# Access Compliance Report

## Public Rights-of-Way

Intersection ID: 42779	Main Street: SILVERSWORD_DR	Cross Street: RED_VULCAN_CT	Location: SW
ADA ID: 5508B77E1443	Ramp Type: PerpDiag	Initial Pass/Fail: Fail	Overall Compliance: No
			Severity Score: 33.75

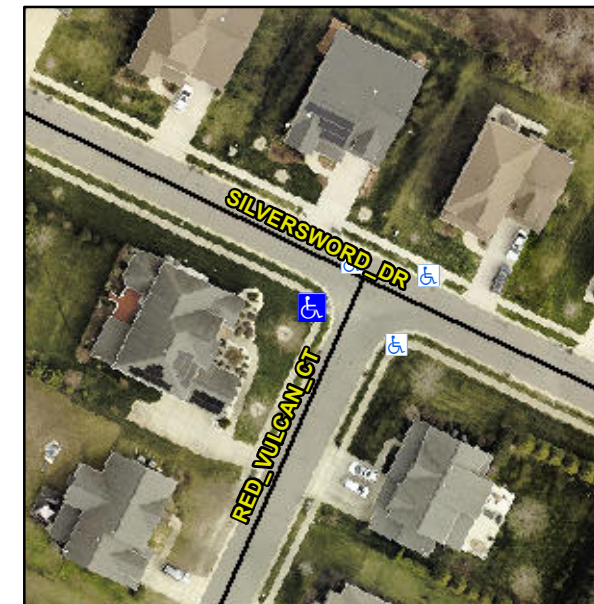
**Not Found, R304.5.1, R304.2.2**

Compliance	Description	Data	Compliance	Description	Data
N/A	Ramp Length (in)	47.0	No	Ramp Slope (%)	12.1
No	Ramp Width (in)	42.0	Yes	Ramp XSlope (%)	1.5
N/A	Flare Type LT	N/A	N/A	Flare Type RT	N/A
N/A	Flare Slope LT (%)	N/A	N/A	Flare Slope RT (%)	N/A
N/A	Flare Traversable LT?	N/A	N/A	Flare Traversable RT?	N/A
N/A	Landing Length (in)	N/A	N/A	DWS Provided?	N/A
N/A	Landing Width (in)	N/A	N/A	DWS Contrast?	N/A
N/A	Landing Slope (%)	N/A	N/A	DWS Length (in)	N/A
N/A	Landing X Slope (%)	N/A	N/A	DWS Full Width?	N/A
N/A	Landing Curb? (Y/N)	N/A	N/A	DWS Offset (in)	N/A
N/A	Shared Landing?	N/A			
N/A	Gutter Ponding?	N/A	N/A	Gutter Slope (%)	N/A
N/A	Gutter Lip Ht (in)	N/A	N/A	Gutter X Slope (%)	N/A
N/A	Painted X Walk1?	No	N/A	Painted X Walk2?	No
	X Walk 1 Direction	To SE		X Walk 2 Direction	To NE
N/A	X Walk 1 Width (in)	N/A	N/A	X Walk 2 Width (in)	N/A
	X Walk 1 Slope (%)	0.4		X Walk 2 Slope (%)	0.5
	X Walk 1 X Slope (%)	3.2		X Walk 2 X Slope (%)	0.8

**Remove & Replace Curb Ramp With Two New Directional Ramps or Equivalent.**
